STAFF REPORT 02/17/2021 MEETING

APPLICATION NUMBER: #21-7090

ADDRESS: 3790 STURTEVANT

SCOPE: REPLACE SIX EXISTING HISTORIC WINDOWS AND TRIM WITH NEW FIBREX WINDOWS

WINDOW OPENING 1

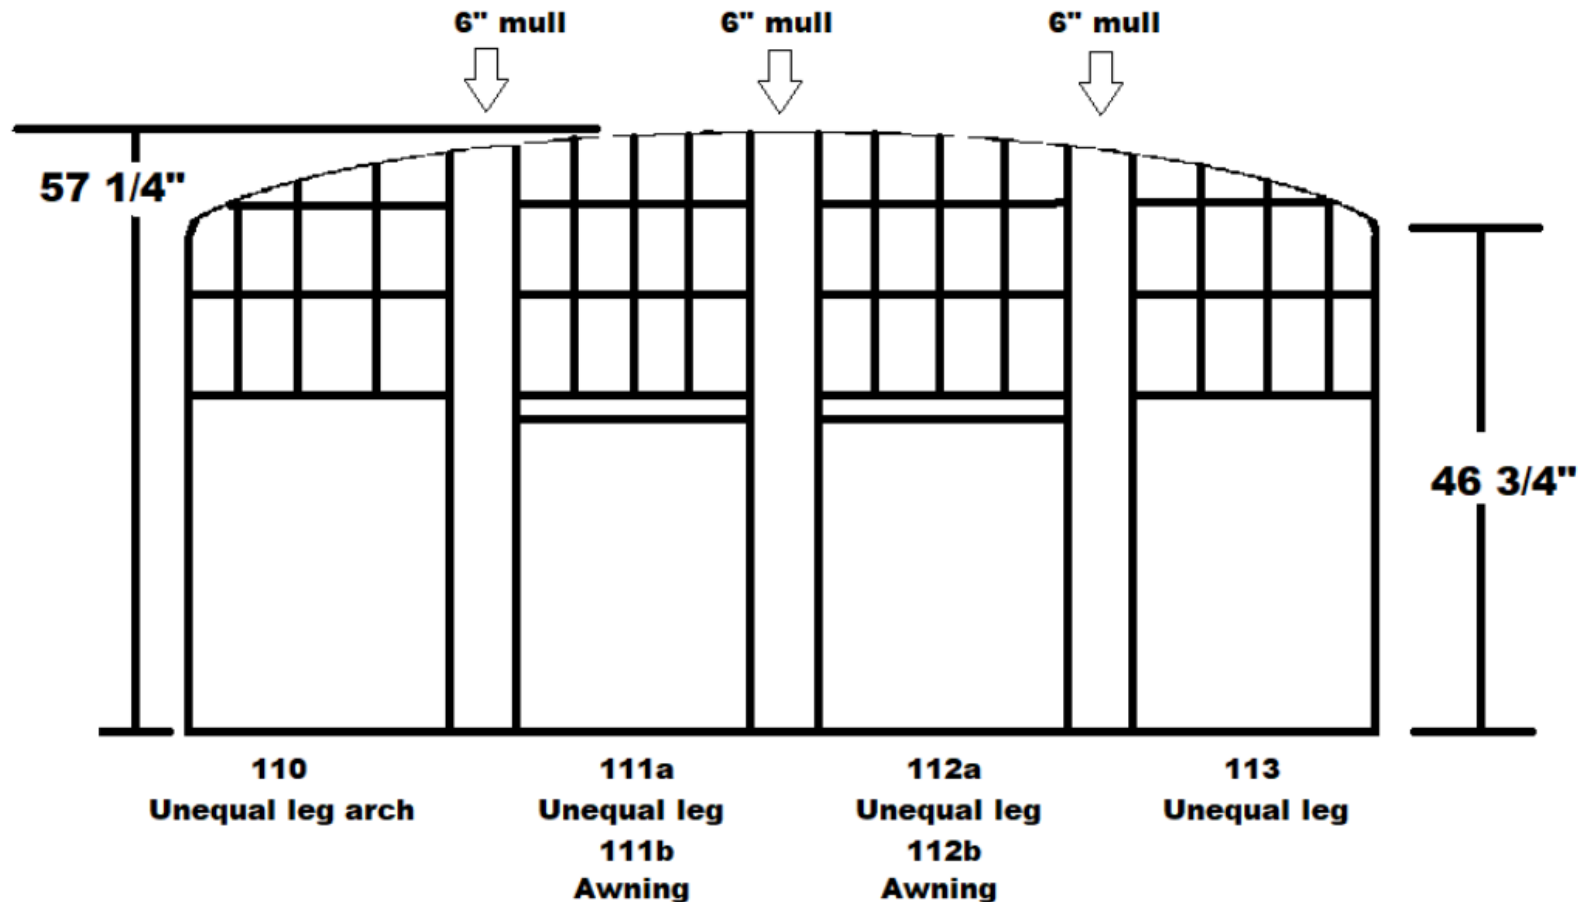
- The application notes that the windows proposed for replacement at the front elevation (opening to the home's living room) are showing "exterior...signs of deterioration and exterior has not been maintained, outside glass "storm windows" are broken out on some of the windows, interior windows won't close all the way to lock properly, and all "pulley" ropes are broken."

- After a review of the applications photos of the existing windows and a visit to the site, staff determined that the sash proposed for replacement are in repairable condition. Furthermore, many of the submitted pictorial examples of exterior deterioration refer to condition issues with the wood storm windows rather than the actual sash.

- **Double Hung**
- **Window is in Livingroom**
- **Exterior shows signs of deterioration and exterior has not been maintained**
- **Outside glass “storm windows” are broken out on some of the windows**
- **Interior windows won’t close all the way to lock properly**
- **All “pulley” ropes are broken**

WINDOW OPENING 2

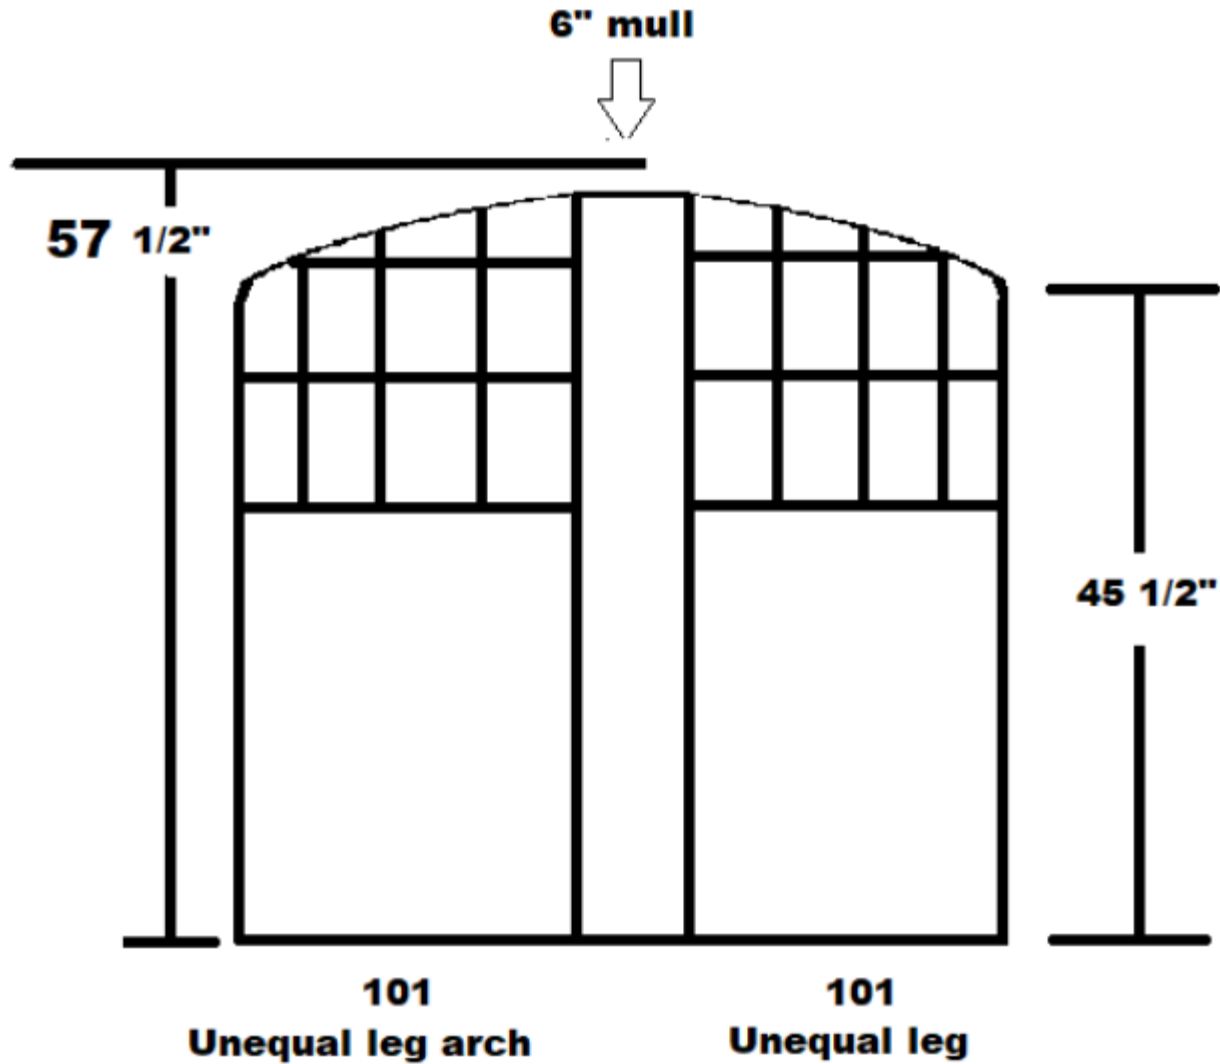
- The application noted that the windows proposed for replacement at the side elevation (opening to the home's stairwell) are showing "exterior...signs of deterioration and exterior has not been maintained, interior windows won't close all the way to lock properly, and all "pulley" ropes are broken."

- **Double Hung**
- **Window is at bottom of stairs**
- **Exterior shows signs of deterioration and exterior has not been maintained**
- **Interior windows won't close all the way to lock properly**
- **All "pulley" ropes are broken**
